Intel[®] Communications Chipset 8900 Series

Specification Update

May 2014

Document Number: 328000-005US

Figure 2. 1000BASE-BX/FC-Pi Transmitter Electrical Specifications

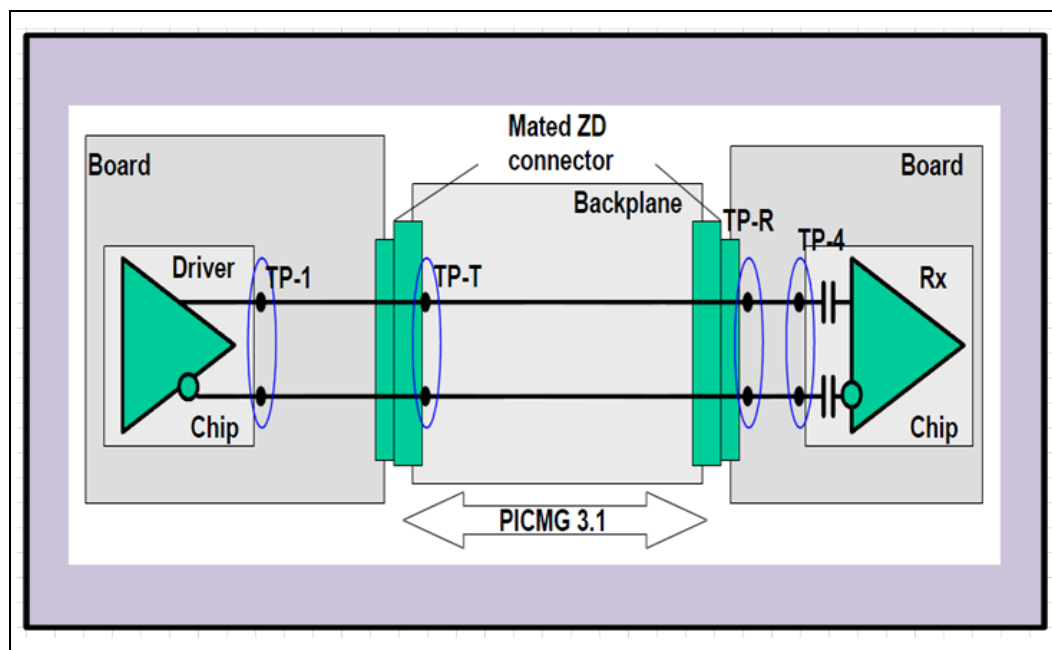
Implication: Although this is a specification violation, it does not affect the functional operation of the interface.

Workaround: Ensure that the signal routing length from TP-1 to TP-4 is greater than 10". Refer to *Intel® Communications Chipset 8900 Series Platform Design Guide (PDG)* for maximum routing length. (See [Figure 2.](#))
